THE WAY WE LIVE

QUEEN ELIZABETH PARK MASTER PLAN CONCEPT EVALUATION REPORT

01 PUBLIC CONSULTATION SERIES #2

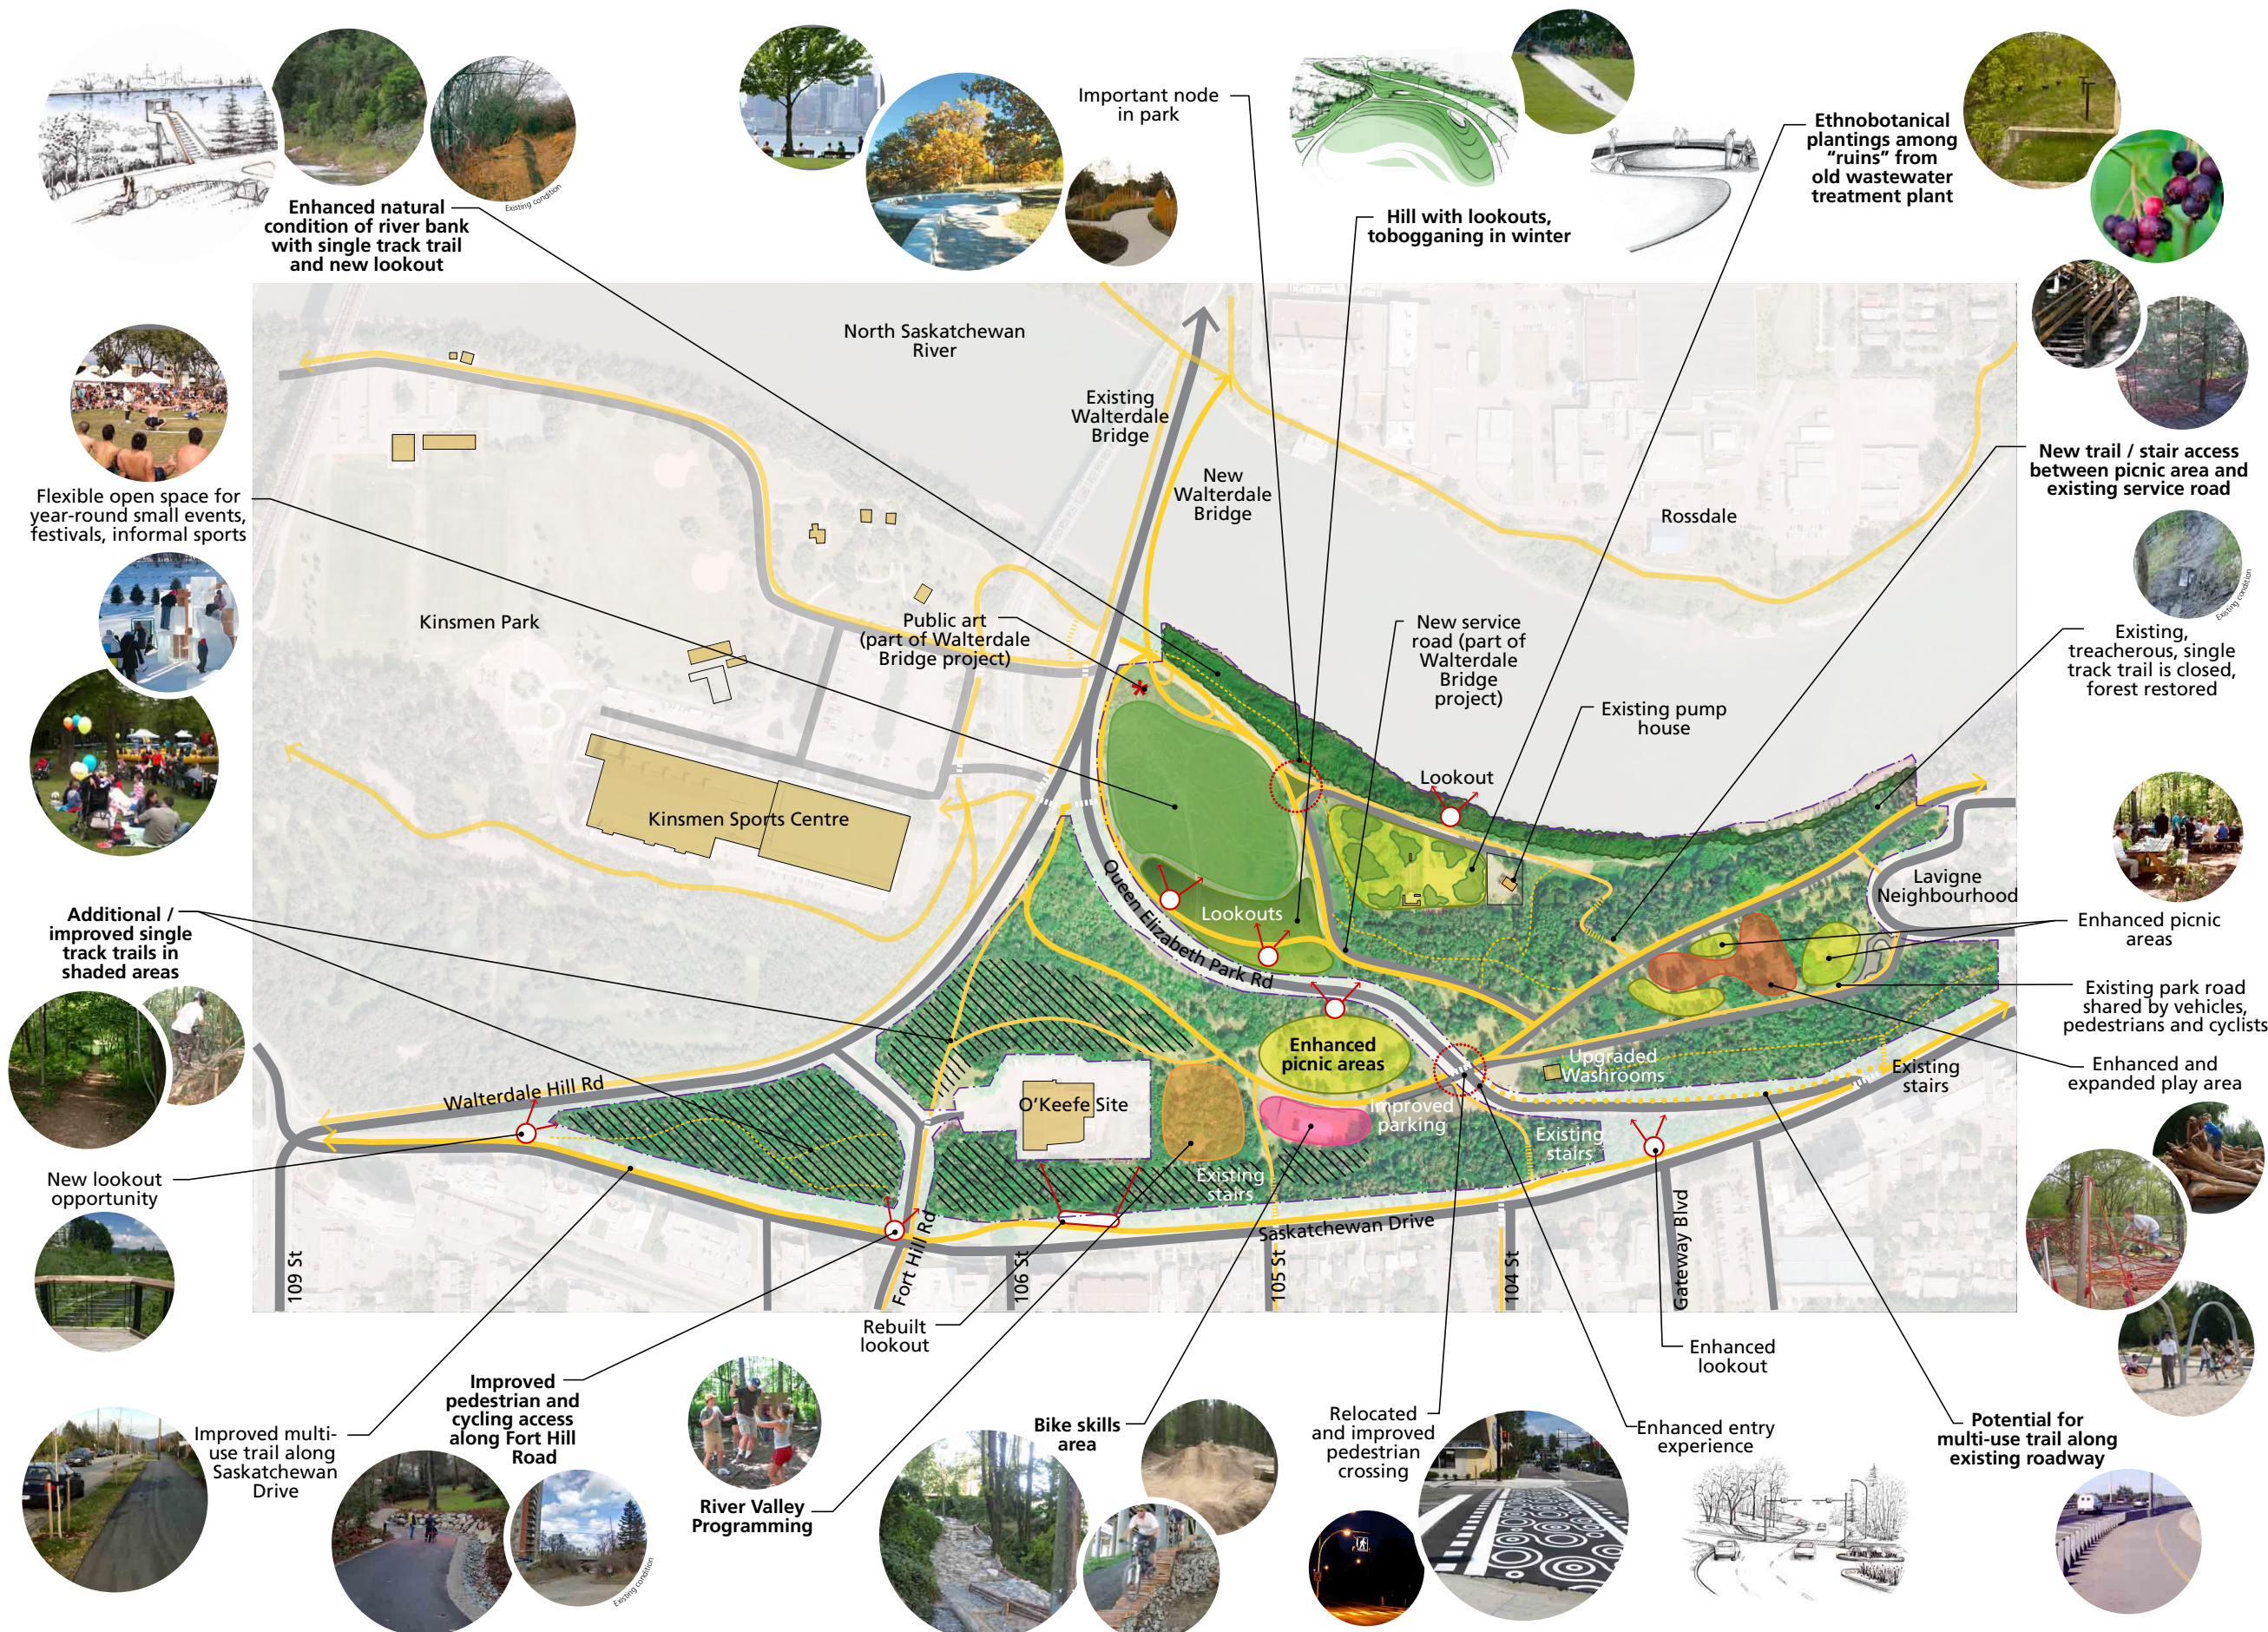
BIKE SKILLS AREA

- Like idea
- Disagree with proposed location by old wastewater treatment plant
- Location for plantings doesn't matter

- There should be a balance in the types of trails; not all trails should be paved
- Concern with environmental degradation; the amount of trees removed should be replanted

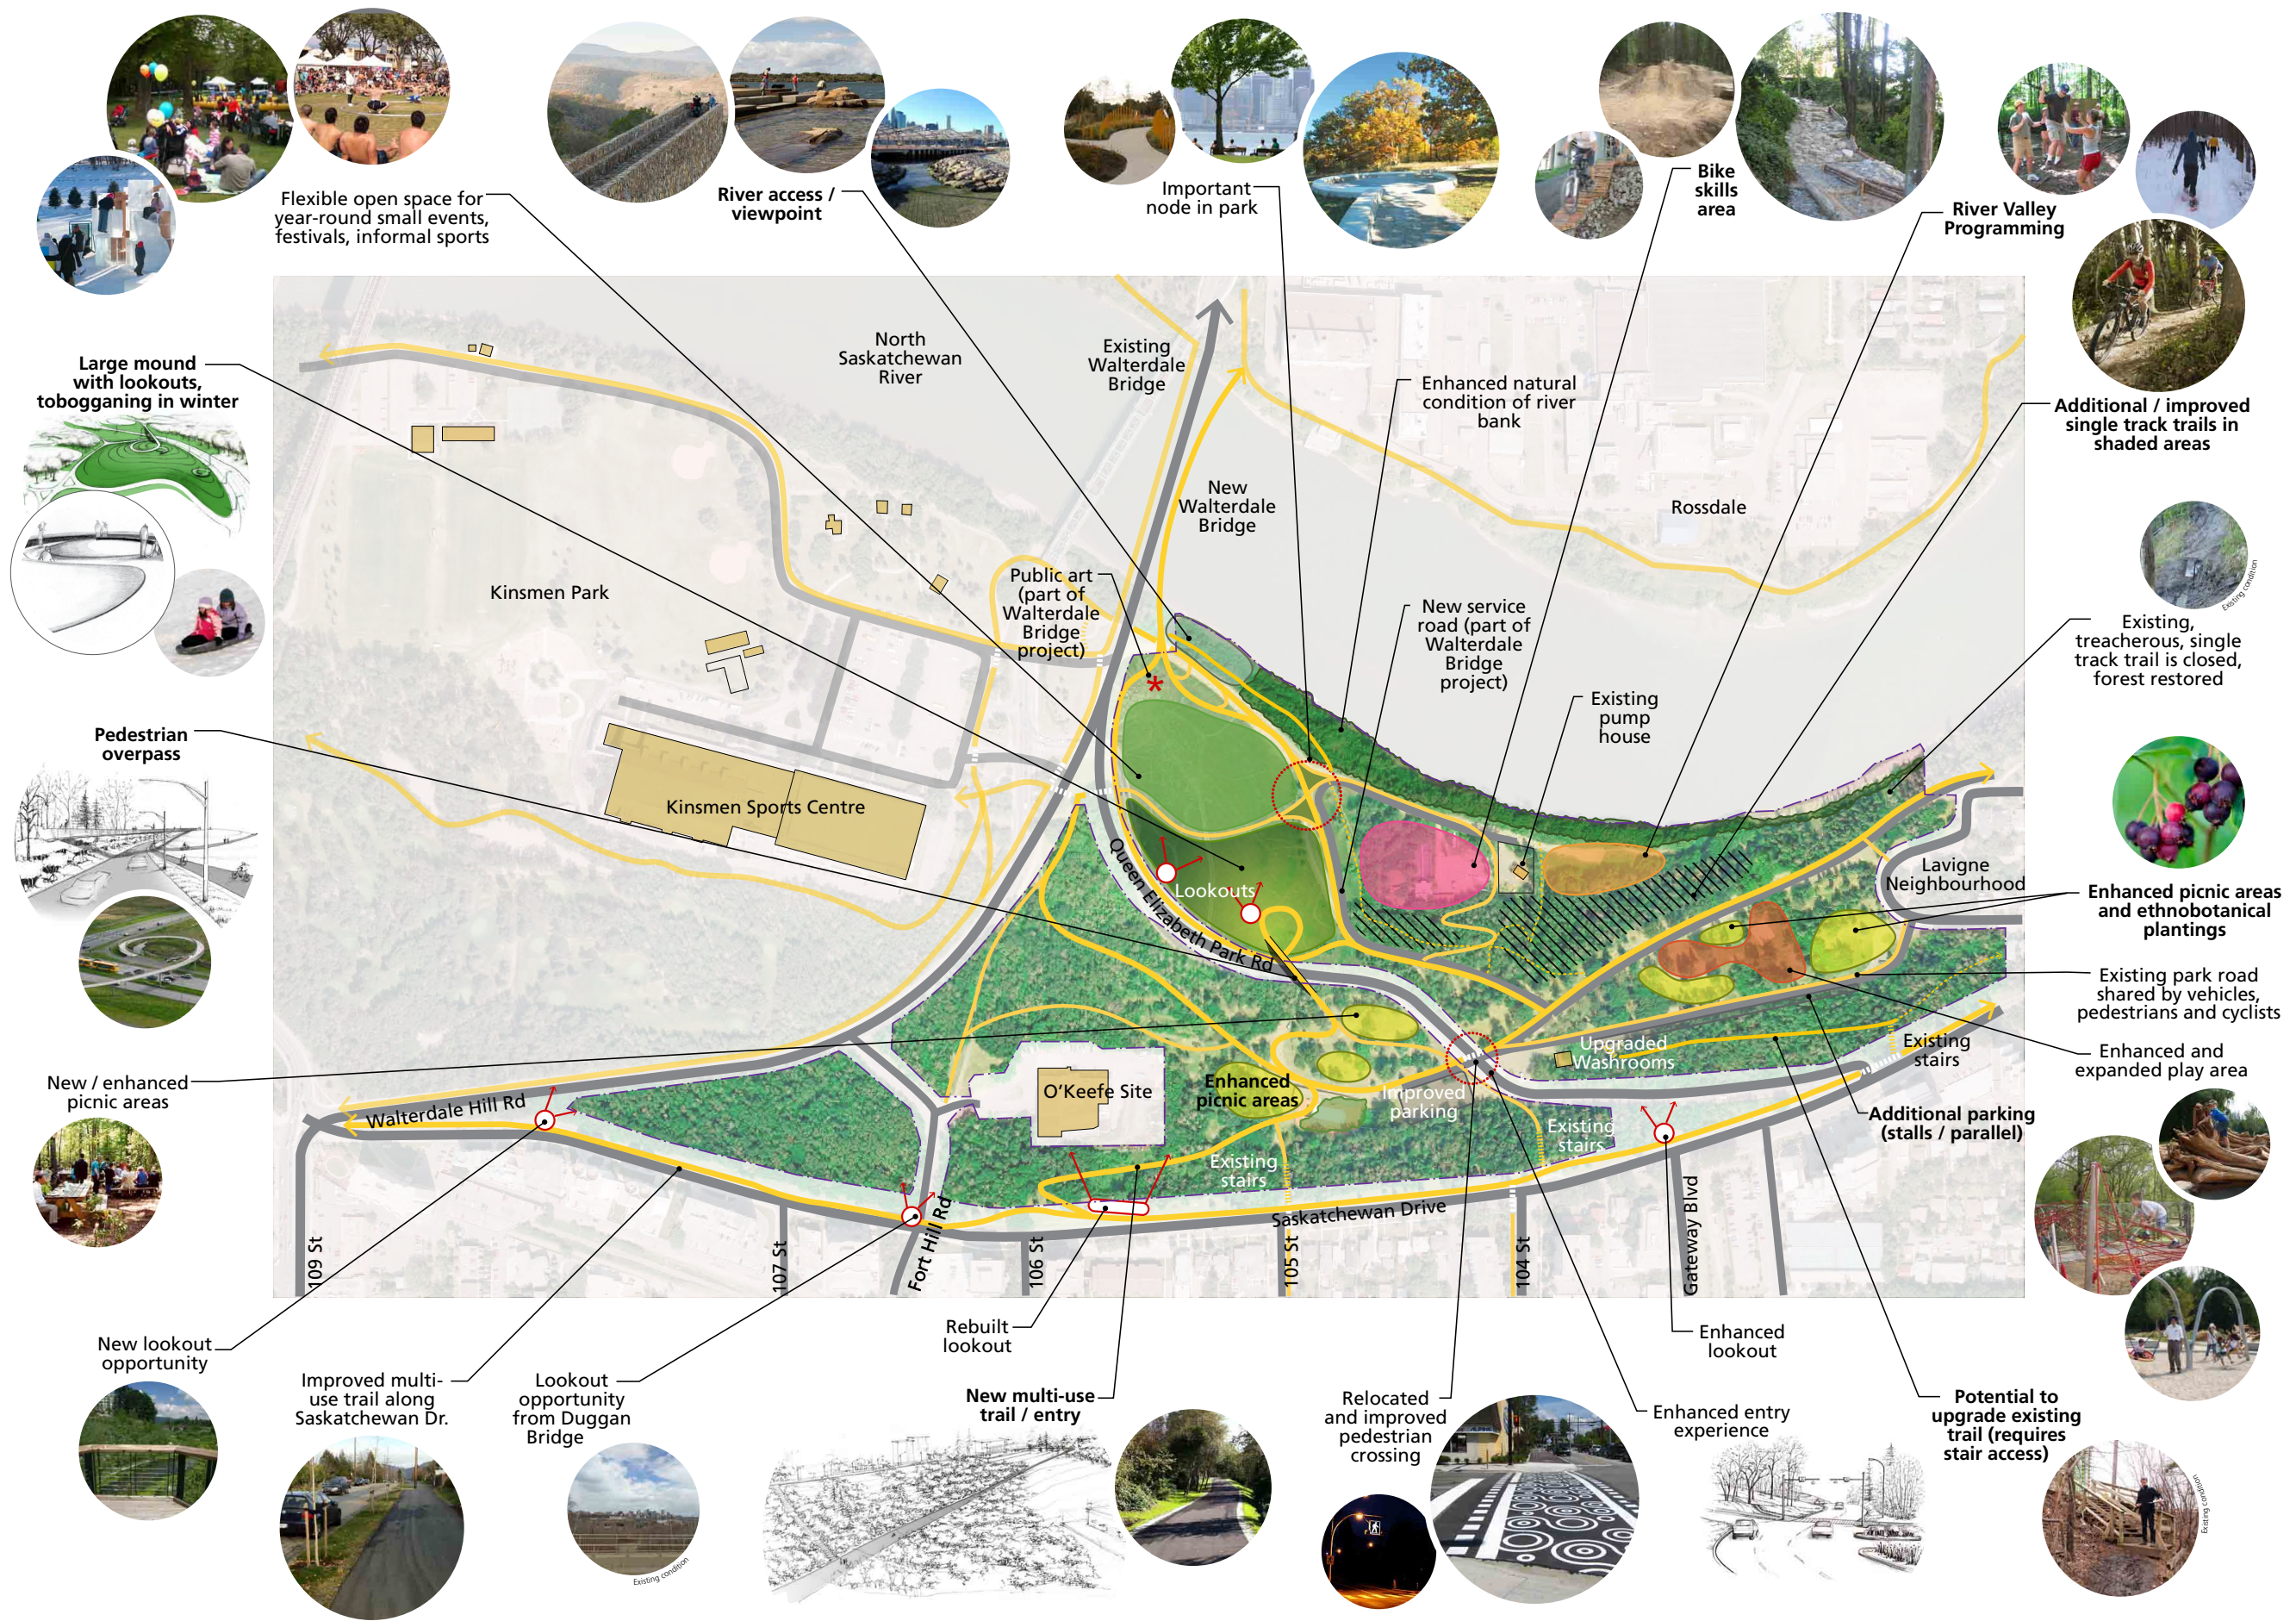
29	I don't think closure of the single lane tracks is a good idea. People use them and will continue to use them even if they are closed down.	Aug 29, 2012 12:39 PM
30	Let's have an ACTIVE plan...ie plan B, not a tranquil plan.	Aug 29, 2012 9:07 AM

31	The Vibrant Riverfront plan is much more conducive to promoting a healthy active lifestyle in Edmonton.	Aug 28, 2012 8:16 PM
32	Please do not improve the single track. It is natural and a thrill from runners and mountain bikers.	Aug 28, 2012 6:10 PM
33	Just more separation of bike and pedestrian traffic by having More "bike" trails to accomplish that. Cycling is only going to more popular as a means of transportation and exercise. Lets get with the times and help this along.	Aug 28, 2012 4:15 PM
34	This is awesome, thank you for you time and hard work.	Aug 28, 2012 3:40 PM
35	When we pave our trails, we disconnect from our ecosystem. Furthermore, we weaken our tendons and muscles that keep us strong through natural trail system use. I have three young girls who confidently manoeuvre dirt and roots and rocks. I would expect that level of skill from them. They should be learning to be strong and to embrace nature in its most natural state, which preserves life and beauty.	Aug 28, 2012 2:07 PM

40	I like plan 2 - the more vibrant one. I use the single track trails, plus the paved	Aug 28, 2012 10:43 AM
